Delmore Fast Track Application

Appendix 8: A21 (Auckland Transport - Stormwater) to Response to Comments letter

Re: Auckland Transport Stormwater Memorandum

Subject: Delmore Development (Upper Orewa): Dam Classification & Dam Breach Flood Hazard Assessment

Figure 1: Location of culverts and inadvertent dams

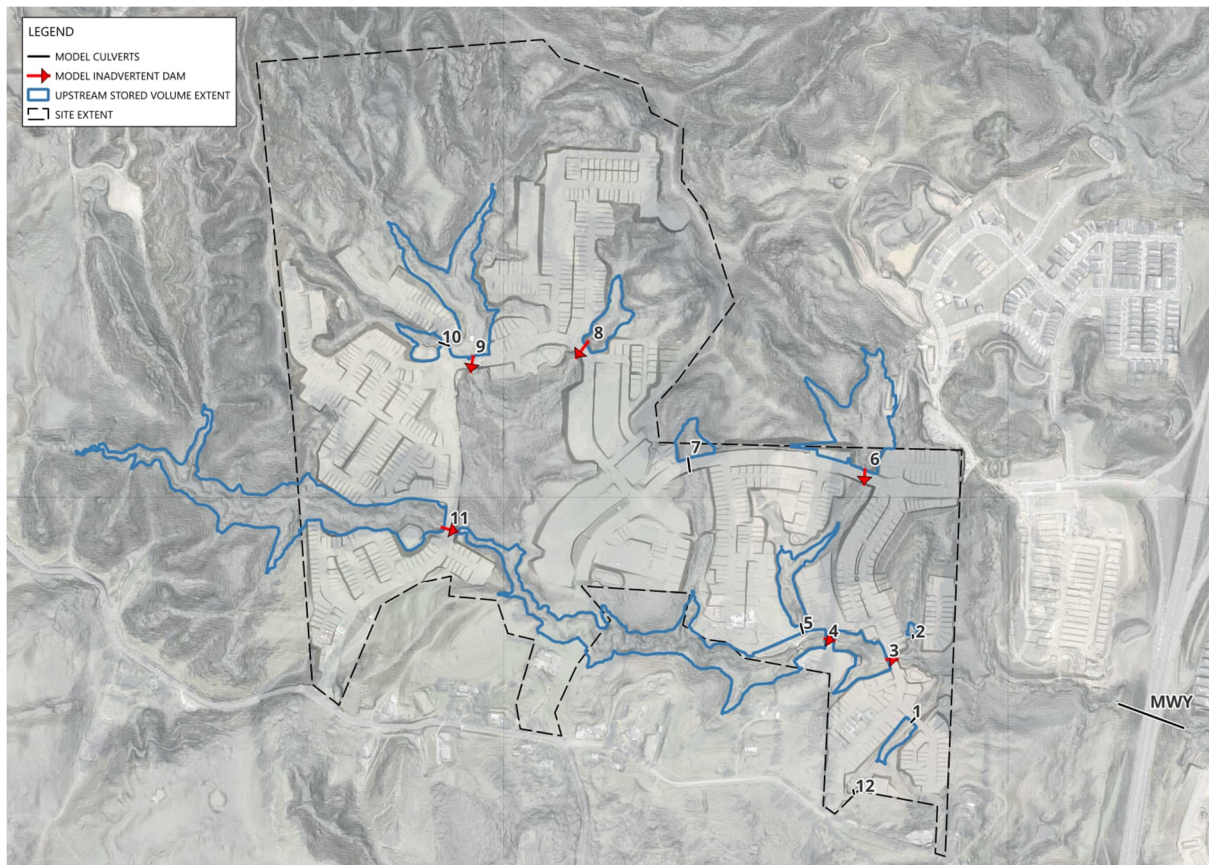
5. It appears that many of the culverts may be a classifiable dam according to	See above.		A Dam Break Assessment is included within Attachment A to

the Building (Dam Safety) Regulations 2022, as the headwater above embedment (Appendix B of the Stormwater Report) exceeds 4 m. However, it is not clear what the volume of water impounded by the culverts is. Can the applicant please clarify which culverts will be classifiable dams under the Building Act 2004 or the Building (Dam Safety) Regulations 2022? Can the applicant then also please demonstrate that these classifiable dams meet the requirements of the Stormwater Code of Practice, the Building Act 2004, and the Building (Dam Safety) Regulations 2022? Note that if there is overlap of requirements, as per section 4.3.9.8.a of the Stormwater Code of Practice, the more stringent requirement will take precedence over the Stormwater Code of Practice requirements.			this memo. A supporting PIC Assessment is included as Attachment B.

Of the twelve culverts assessed, Culverts 3, 4, 6, 8, 9, and 11 are identified as *inadvertent dam*. The remaining six culverts (Culverts 1, 2, 5, 7, 10, and 12) do not meet both criteria and are not identified as *inadvertent dam* (refer to Table 1 for results). Figure 1 shows the location of all the culvert embankments included in the classification assessment.
